ADDENDUM NUMBER 1

Bid #33-17

Outer Islington Street Improvements

Issued January 25, 2017

DATE: FEBRUARY 2, 2016		PROJECT NO.: Cop-002	
SCALE: 1:20		MARC R. BATCHELDER, PE ENGINEER OF RECORD	
FOR: Outer Islington St Sidewalk Design Portsmouth, NH 03801		Seaport Engineering, LLC PORTSMOUTH, NH (603) 498-8449 www.seaporteng.com	
TITLE: UTILITIES PLAN and PROFILE		C-2C

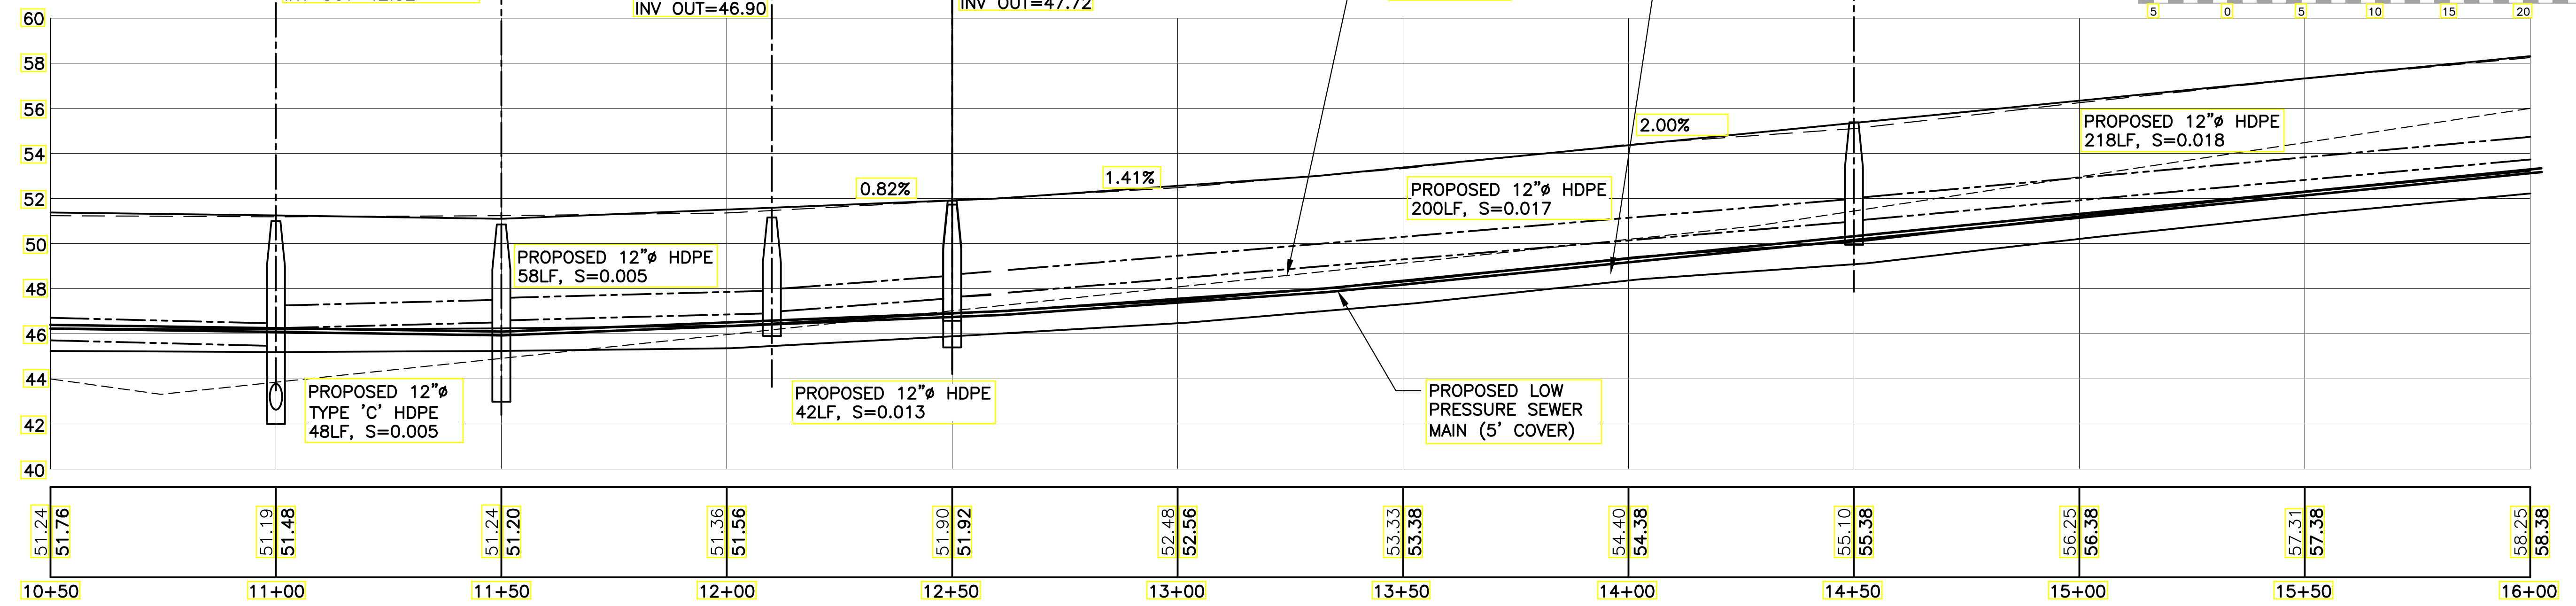
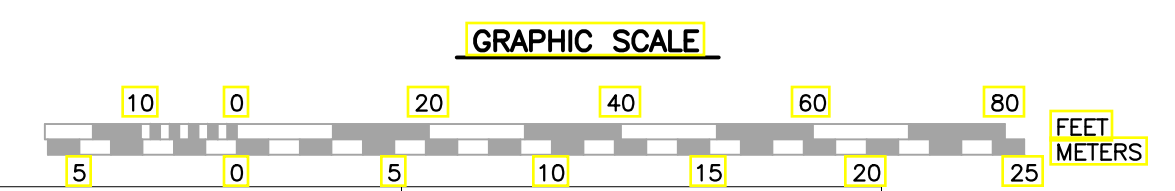
Question 2: An existing gas main is shown on Sheets C-2D and C-2E, but are not shown on C-2A, C-2B, and C-2C. Where does the gas main end?

Answer: The gas main was inadvertently omitted from Sheet C-2C. The gas main continues to approximately sta. 14+10LT where it is capped. A revised Sheet C-2C dated 1/19/2017 is attached as part of this addendum and will supersede the previous plan.
